PROJECT: BRATTLEBORO, VERMONT
IM 019-1(50)

W.E. DAILEY INC.
PRECAST CONCRETE PRODUCTS
3 AIRPORT ROAD, BRATTLEBORO, VT 05302
TEL: (802) 742-4416 FAX: (802) 742-2719
DATE: 1/4/2011 REVISIONS: 2 INITIAL SUBMISSION
DRAWN BY: DRAFTER: ENG.

I-91 BRATTLEBORO, VERMONT
OVER MAPLE ST.

BEAM TYPE "A3-NB"
REINFORCEMENT DETAILS

STEM END DETAIL

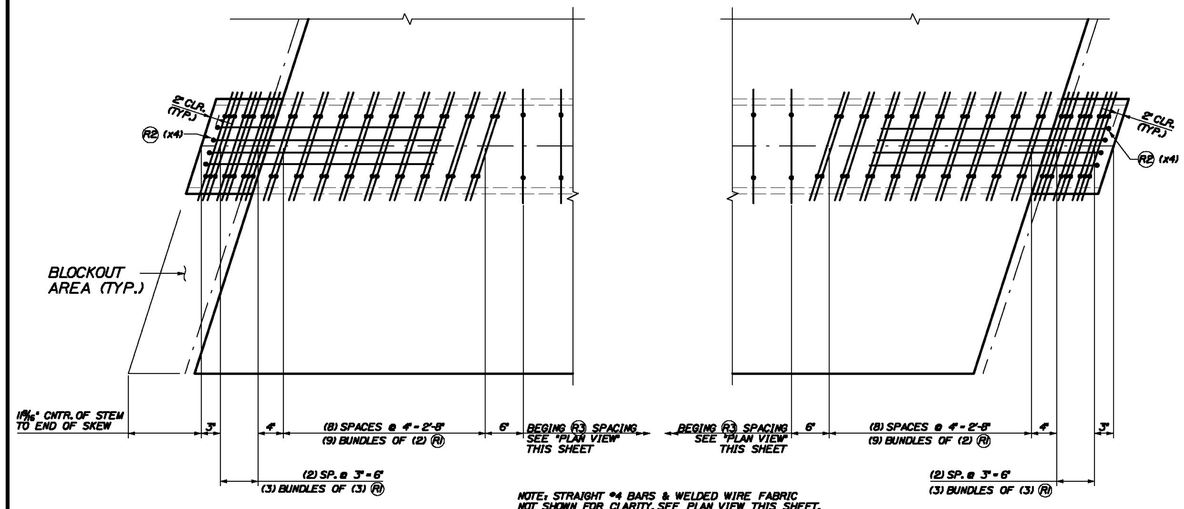
Add notes or diagrams that show required strand projections as shown in the design drawings on sheet 406, note 1
